HISTORIC AND DESIGN REVIEW COMMISSION

March 01, 2017

HDRC CASE NO: 2017-030
ADDRESS: 314 DONALDSON AVE
LEGAL DESCRIPTION: NCB 1931 BLK 38 LOT 24
ZONING: R-6, H
CITY COUNCIL DIST.: 7
DISTRICT: Monticello Park Historic District
APPLICANT: Nathan Bailes, The Gerloff Company
OWNER: Maria Vargas
TYPE OF WORK: Revisions to previous approval of window repair and replacement
REQUEST:

Window Screen

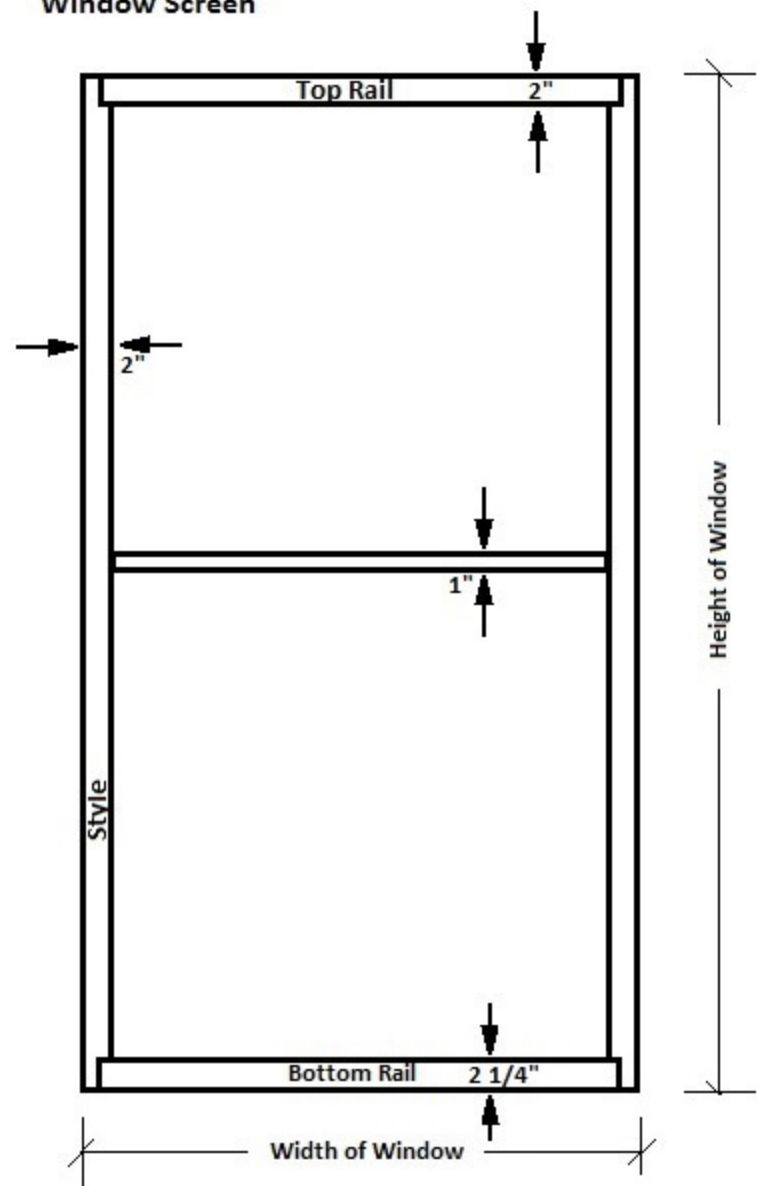
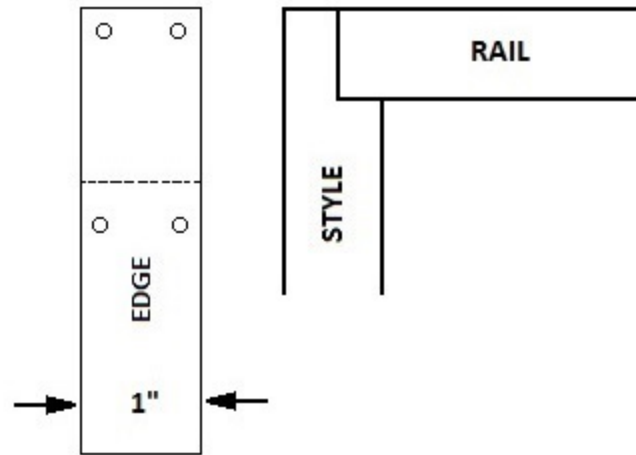
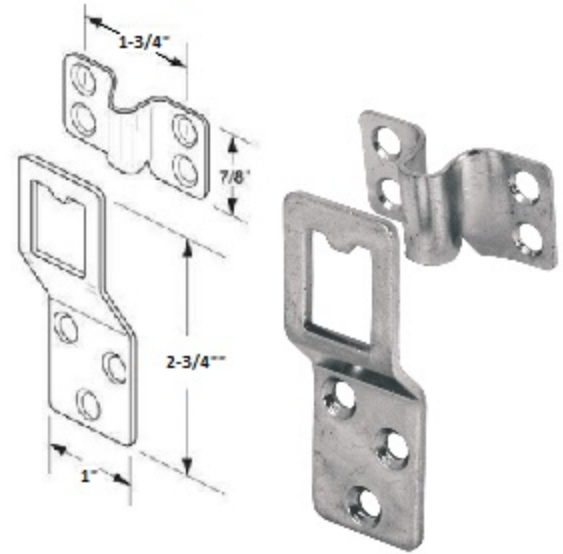
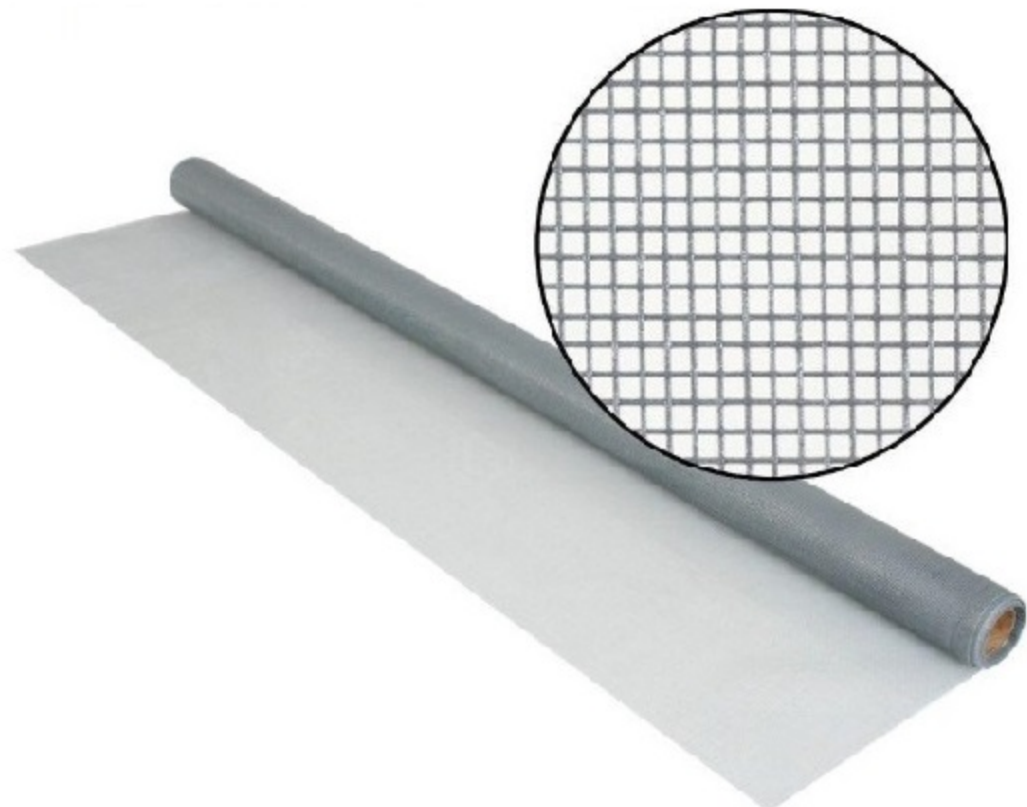
- f. The proposed window screens will cover vinyl windows on the left and right elevations. They are to be installed inset within the stucco frame, and installed each with two hinges. Previously there were non-original aluminum screens in place. According to the Guidelines for Exterior Maintenance and Alterations 6.B., replace non-historic elements with those that are typical of the architectural style of the building. Staff finds that window screens are found on Spanish eclectic style homes in front of wood windows of different configurations, and that their installation is generally appropriate provided that all other guidelines for windows are met.

Item #3: Staff does not recommend wood screens as a solution to conceal inappropriate replacement windows. If the HDRC approves request items 1 and 2 based on the circumstances presented, then staff recommends approval of the proposed wood screens as submitted.
